Your Ref: APP/12/00585

Our Ref: PLAN-000732

Proposal: Change of use from public amenity land to car parking consisting of 2No. private parking spaces and 6No. public parking space and incorporating alterations to dropped kerb, installation of 6No. bollards and new access area markings.**Site: Land fronting, 37-41 Sharps Road, Havant, PO9 5QJ.****APP/12/00585**

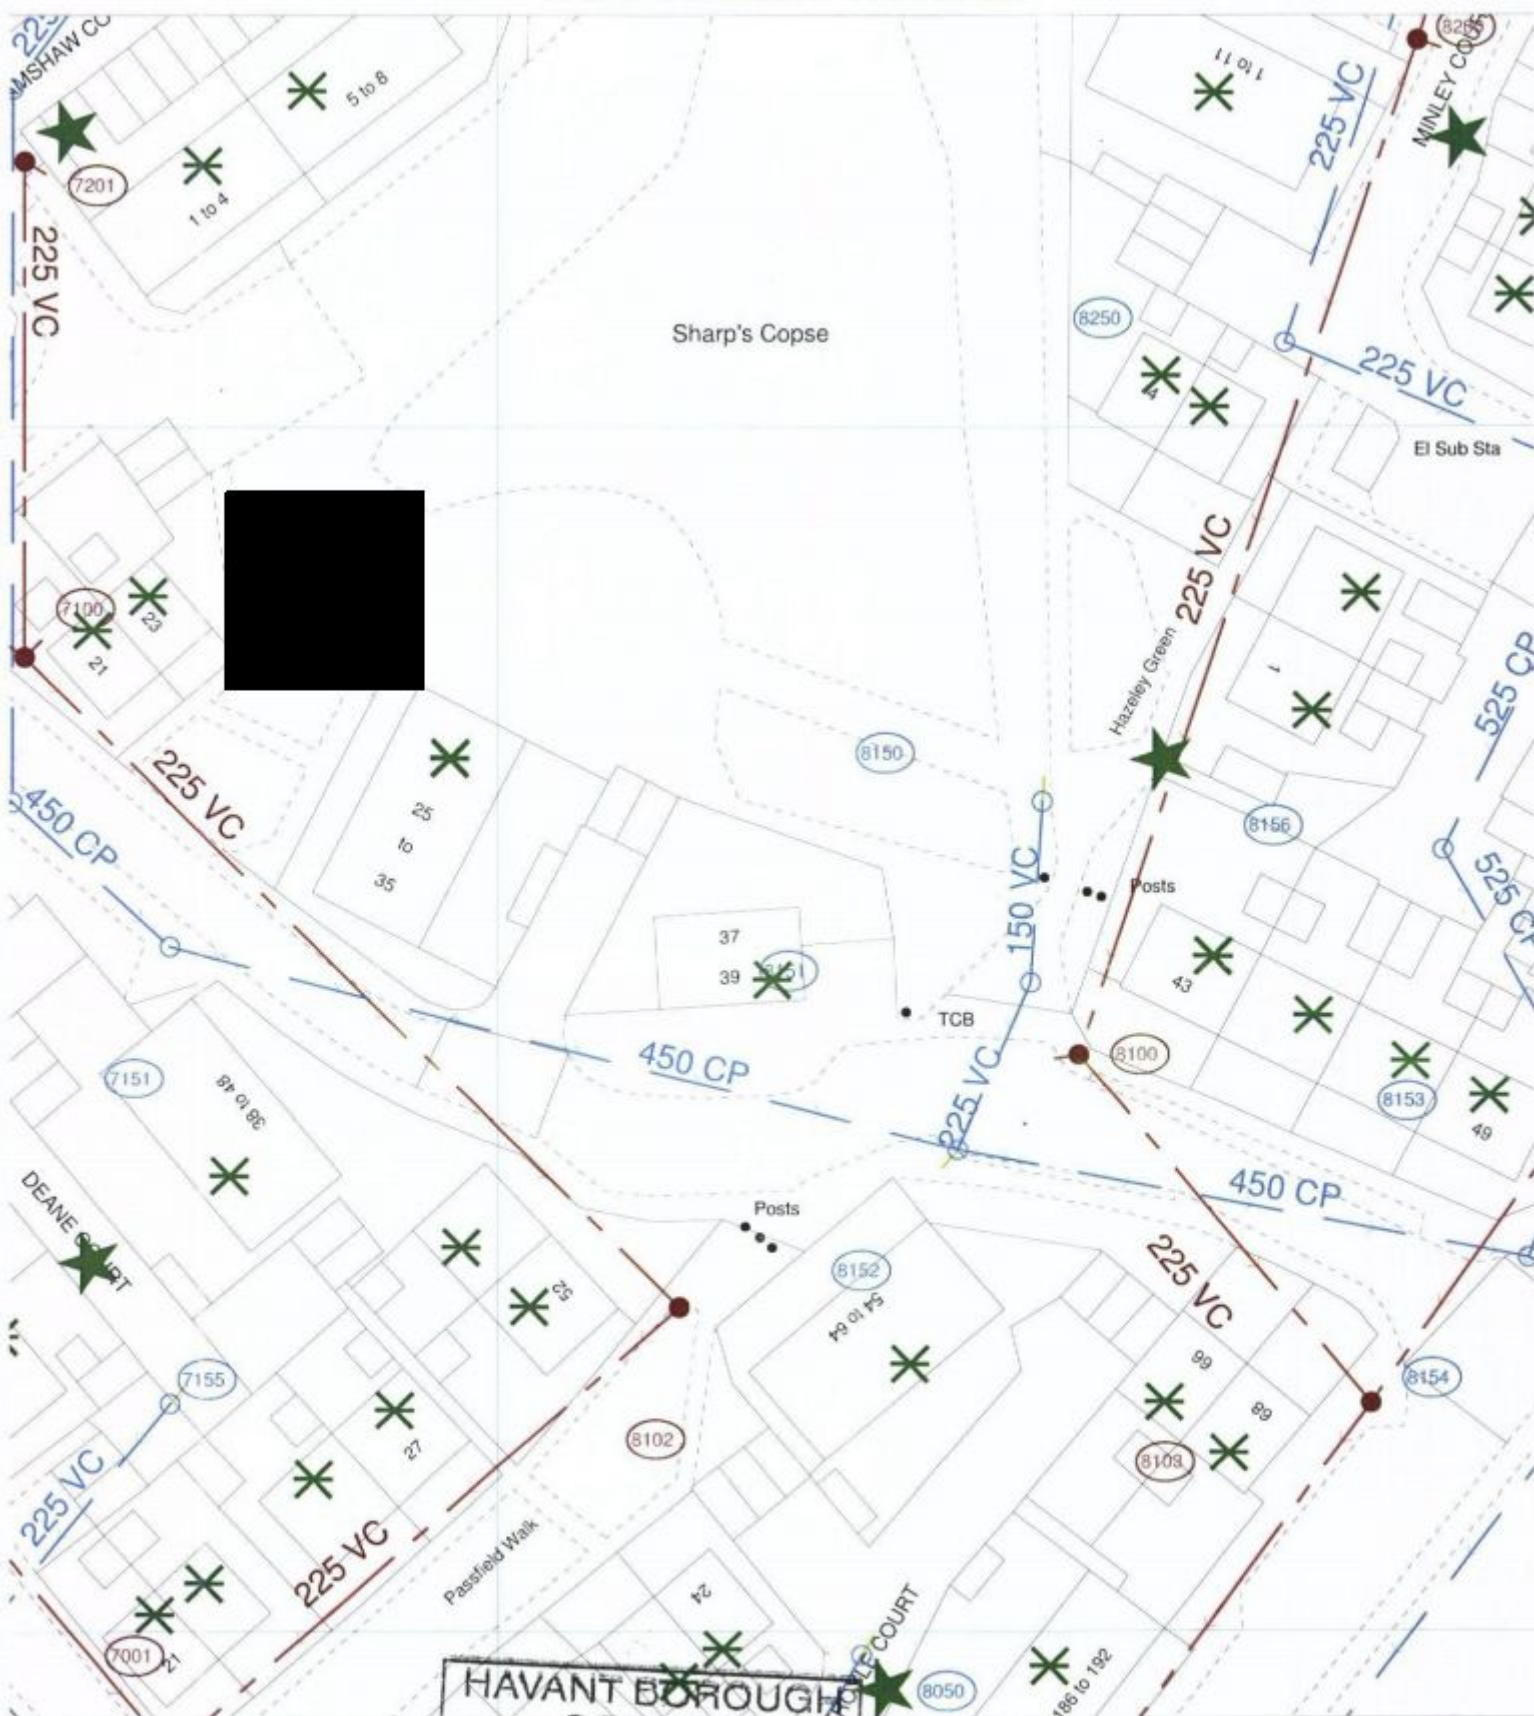
Please find attached a plan of the sewer records showing the approximate position of a public sewer crossing the site. The exact position of the public sewers must be determined on site by the applicant. Please note:

No development or new tree planting should be located within 3.5 metres either side of the centreline of the public sewer and all existing infrastructure should be protected during the course of construction works.
